Project	IEEE 802.16 Broadband Wireless Access Working Group < http://ieee802.org/16 >	
Title	Symmetric UL/DL diversity permutations for OFDMA PHY	
Date Submitted	2004-11-04	
Source(s)	Ran Yaniv, Tal Kaitz, Vladimir Yanover, Naftali Chayat Alvarion Ltd.	ran.yaniv@alvarion.com tal.kaitz@alvarion.com
	Yuval Lomnitz Intel	yuval.lomnitz@intel.com
	Dave Pechner, Todd Chauvin, Doug C. Dahlby Arraycomm	dpechner@arraycomm.com chauvin@arraycomm.com dahlby@arraycomm.com
Re:	Call for contributions, IEEE P802.16e/D5 Sponsor Ballot	
Abstract		
Purpose		
Notice	This document has been prepared to assist IEEE 802.16. It is offered as a basis for discussion and is not binding on the contributing individual(s) or organization(s). The material in this document is subject to change in form and content after further study. The contributor(s) reserve(s) the right to add, amend or withdraw material contained herein.	
Release	The contributor grants a free, irrevocable license to the IEEE to incorporate material contained in this contribution, and any modifications thereof, in the creation of an IEEE Standards publication; to copyright in the IEEE's name any IEEE Standards publication even though it may inc

Figure 219 – Illustration of OFDMA frame with multiple zones

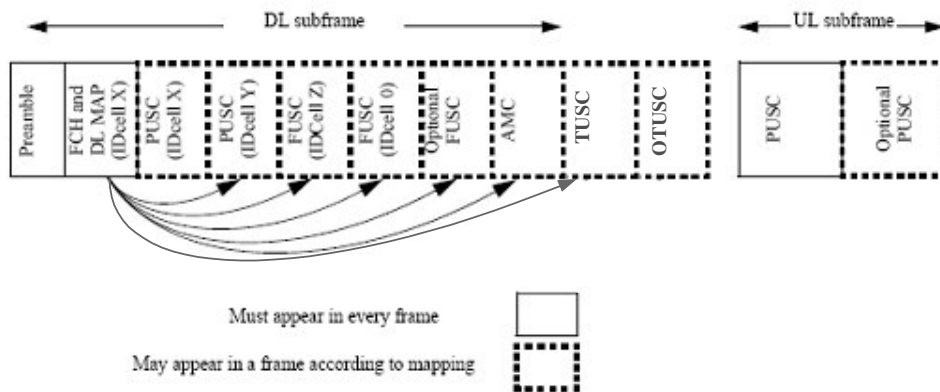
3. [Replace figure 219 on page 503 with the following figure]

Figure 252e – Mapping of data subcarriers in STC with matrix indicator A.

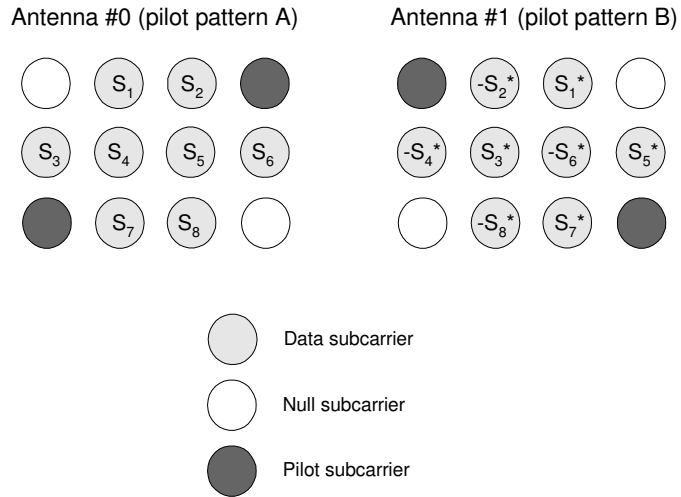
Two STC modes for 2-antenna configuration are defined for the TUSC structure. The first mode, identified by STC matrix indicator ‘A’, provides STC rate of 1 by encoding subcarrier pairs within each tile. In this mode, the tiles shall be allocated to subchannels and the data subcarriers enumerated as defined in 8.4.6.1.2.4. The pilots in each tile shall be split between the two antennas and the data subcarriers shall be encoded in pairs after constellation mapping, as depicted in figure 252e. The data subcarriers transmitted from Antenna #0 follow the original mapping defined in 8.4.6.1.2.4.
